CITY OF CAMBRIDGE
BUILDING DIVISION

THESE PLANS have been examined for compliance with the Ontario Building Code Requirements. A Building Permit is in Order to issue subject to any changes noted under the condition that the building will be constructed in accordance with the code

WILLOW 2 (GR)
ELEVATION 1, 2 & 3

TITLE SHEET
BARLASSINA CONSTRUCTION
CITY OF CAMBRIDGE

BASEMENT PLAN EL-2
BARLASSINA CONSTRUCTION
CITY OF CAMBRIDGE

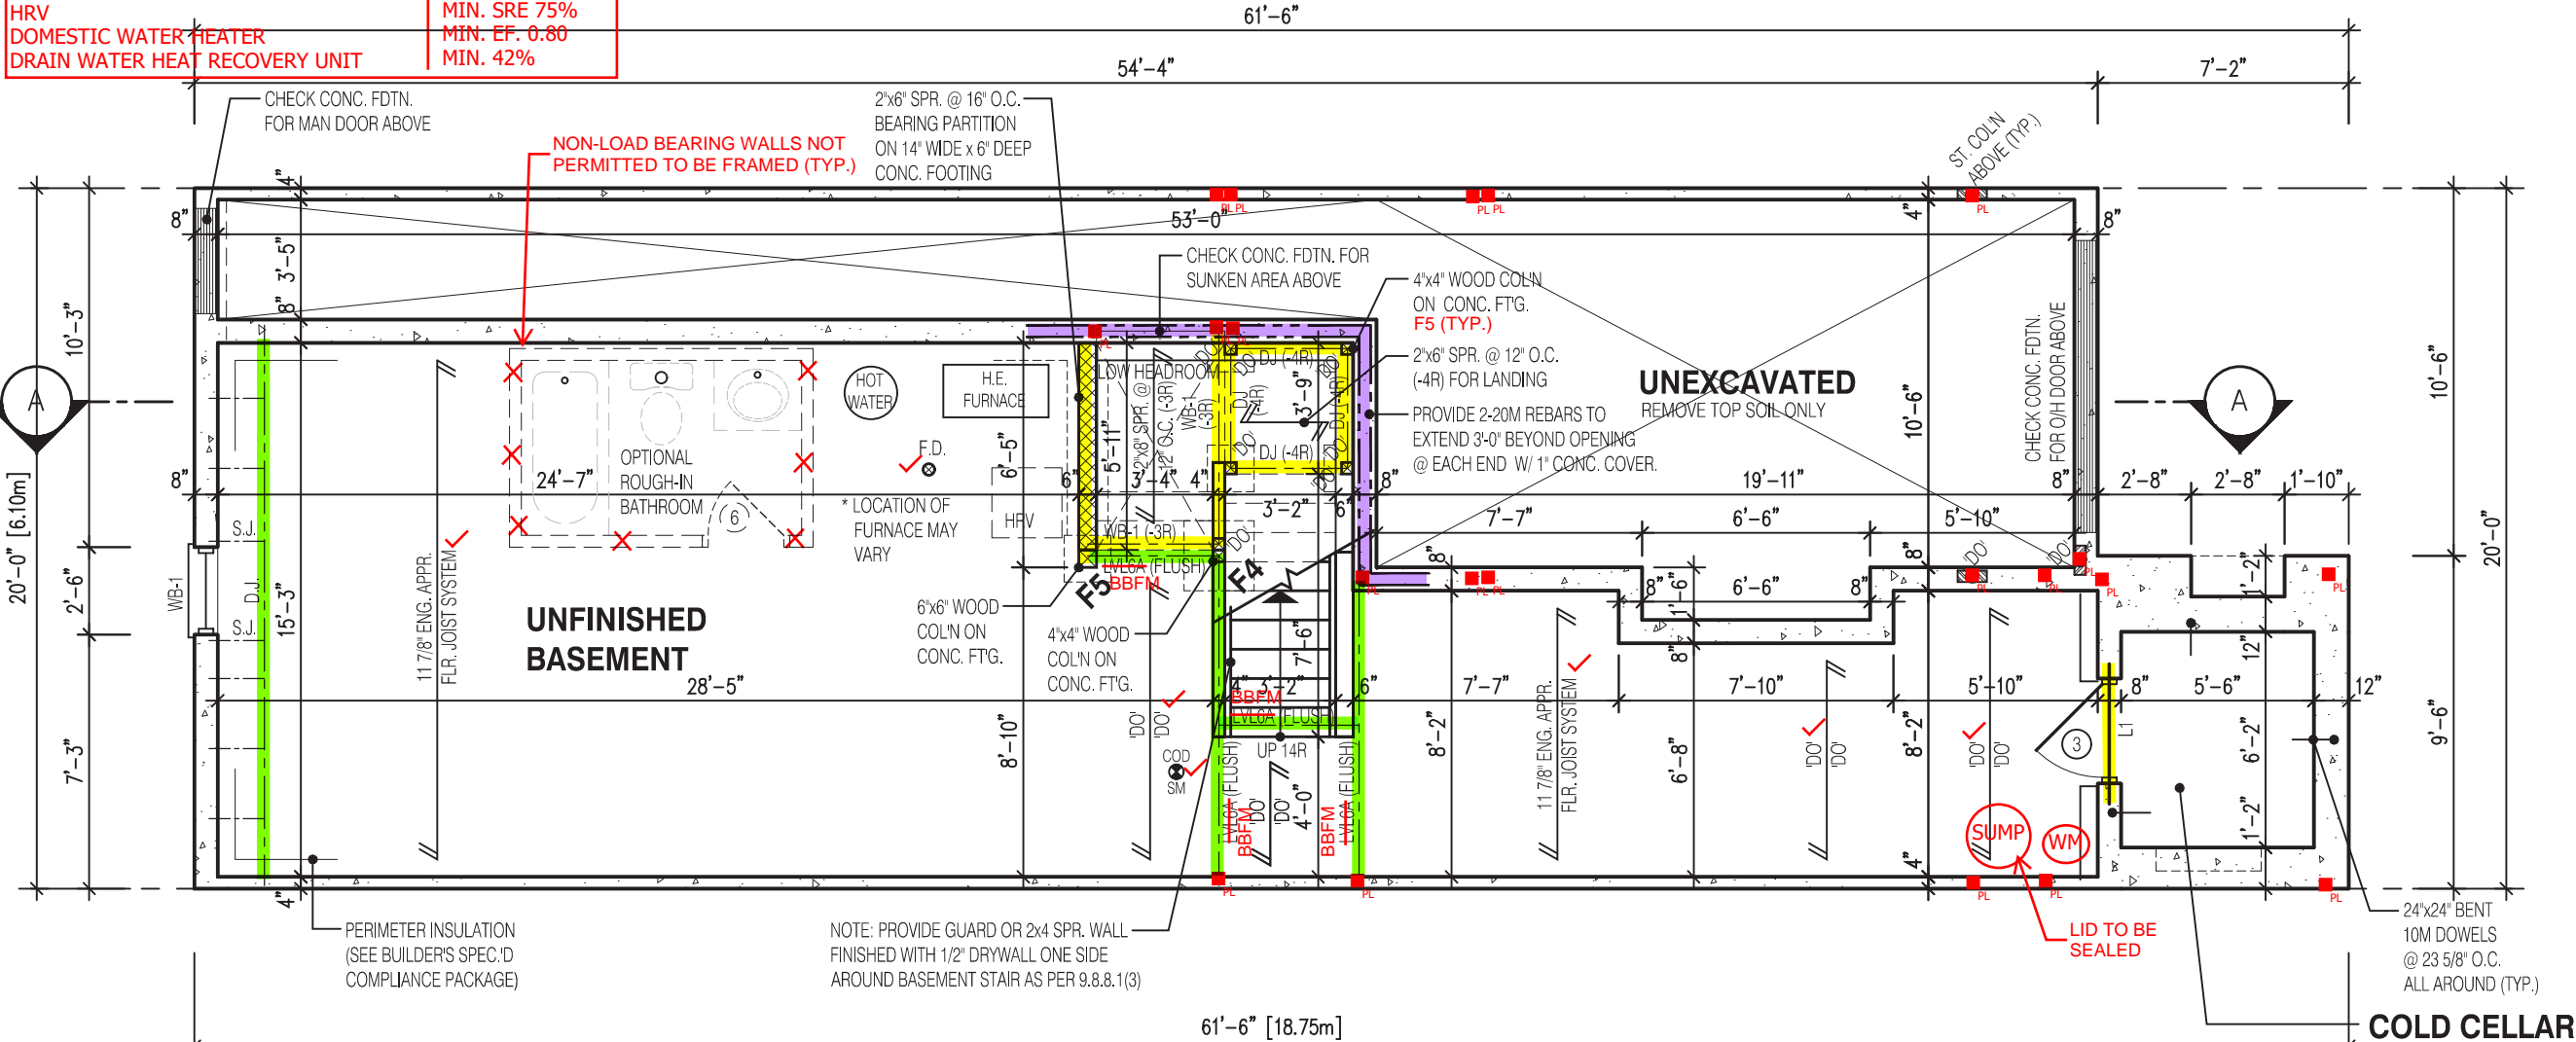
VERIFY WATER METER AND DWHR
UNIT LOCATION WITH INSPECTOR

SPRAY FOAM/RIGID INSULATION TO BE
PROTECTED AS PER 9.10.17.10.(1)

WATER METER TO BE INSTALLED WITHIN 2m
(6'-6") FROM THE POINT THE WATER SERVICE
PIPE MEETS THE BUILDING LINE

REQUIRED CONTINUOUS INSULATION
CANNOT BE INTERRUPTED BY FRAMING
MEMBERS SUCH AS STUDS

FRONT ELEVATION 2
BARLASSINA CONSTRUCTION
CITY OF CAMBRIDGE

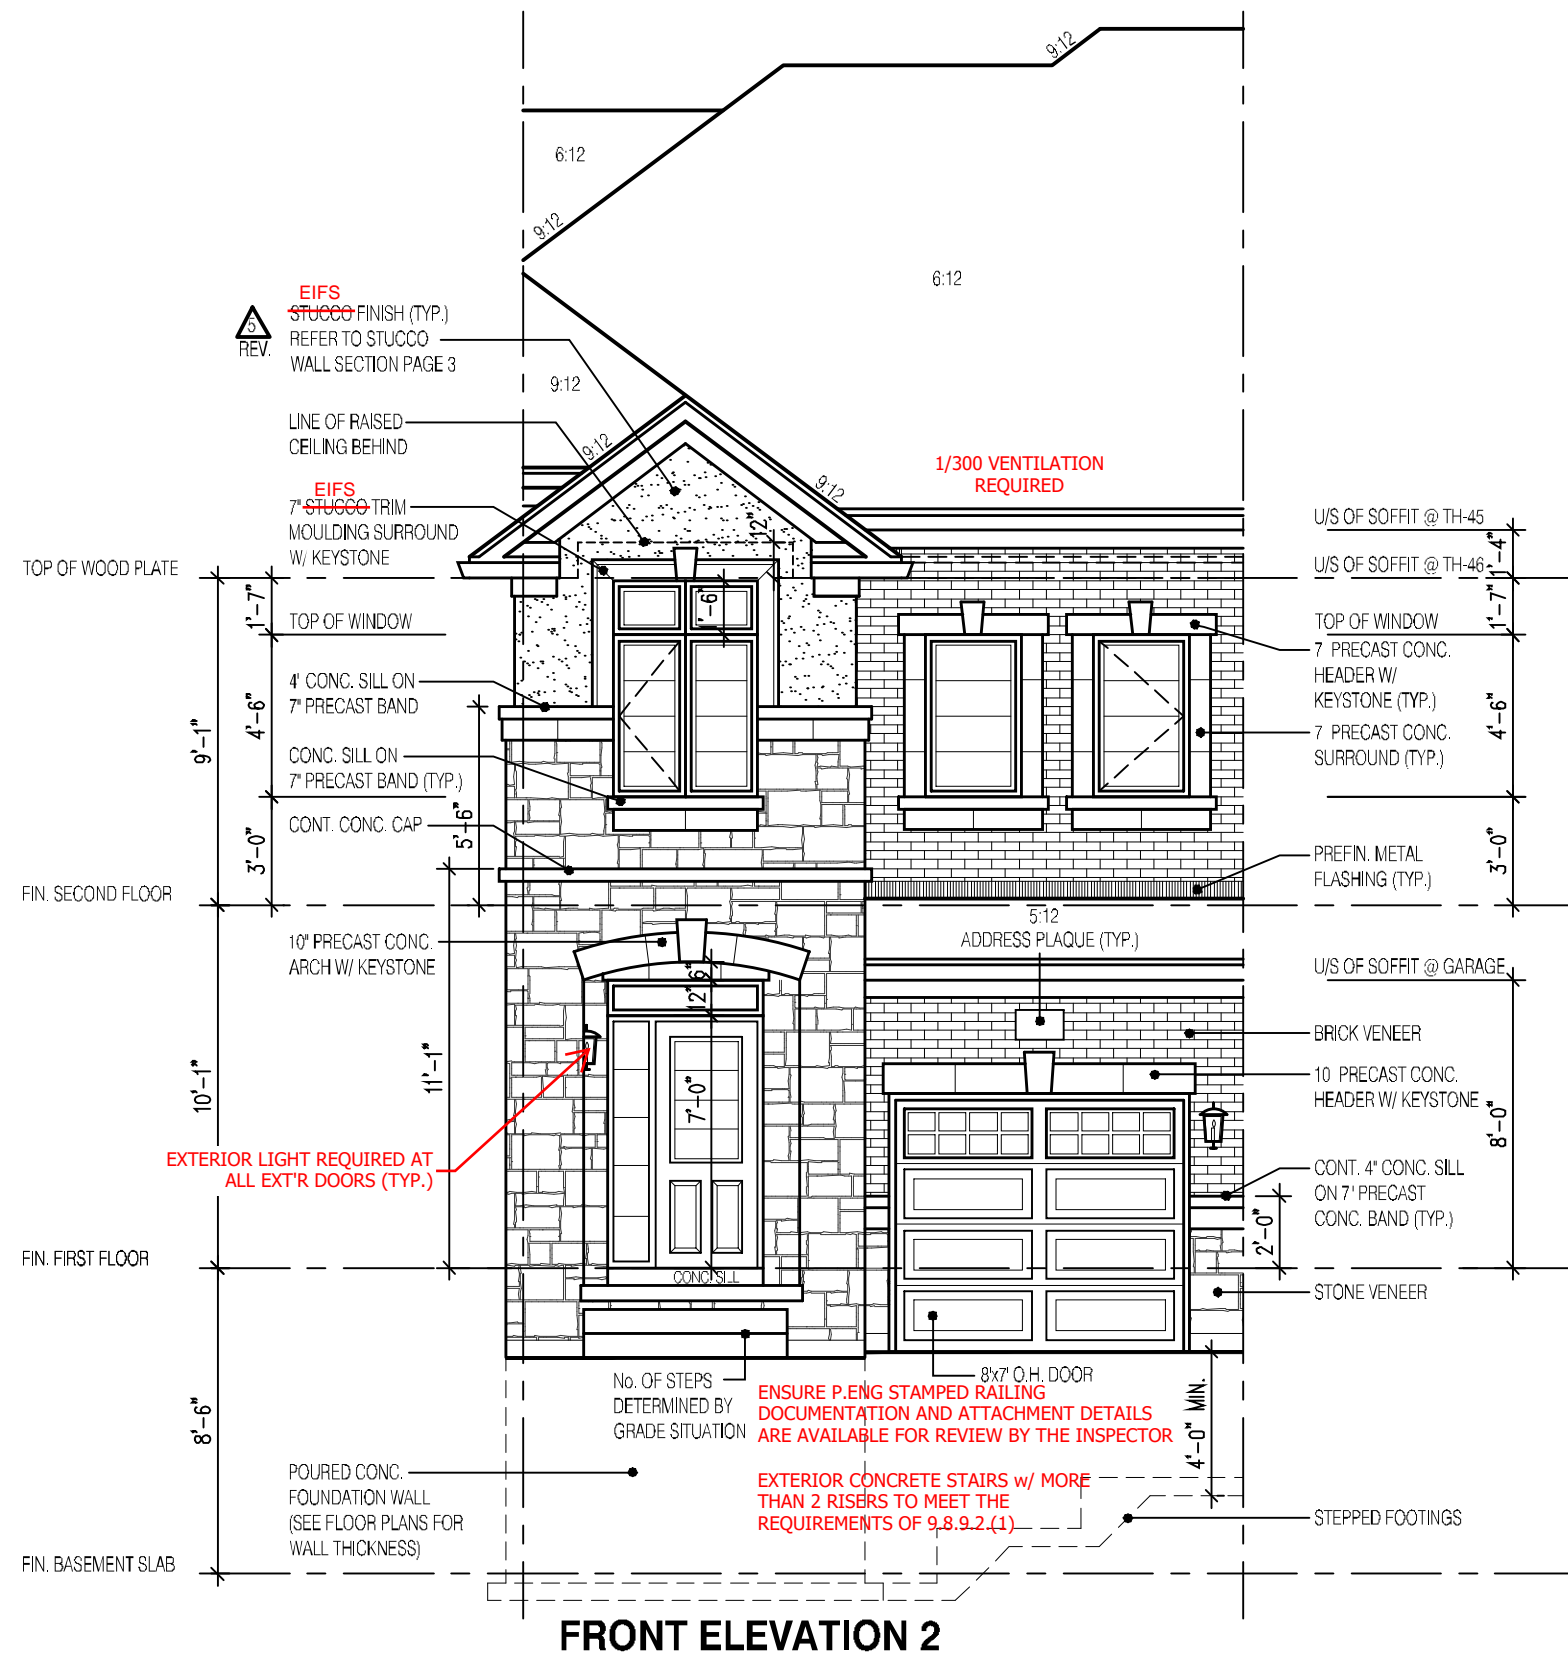
7		
6		
5	MAR. 8, 2023	REV. STUCCO NOTE AS PER CITY COMMENT, REISSUED FOR PERMIT
4	AUG. 31, 2022	ISSUED BUILDING PERMIT
3	AUG. 29, 2022	COORDINATED WITH FLOOR, ROOF & ENGINEER'S COMMENTS
2	JUNE 20, 2022	PREPARED TO PRE-COORDINATION STAGE & ISSUED TO CLIENT
1	MAR. 28, 2022	ISSUED TO CLIENT FOR BROUURE
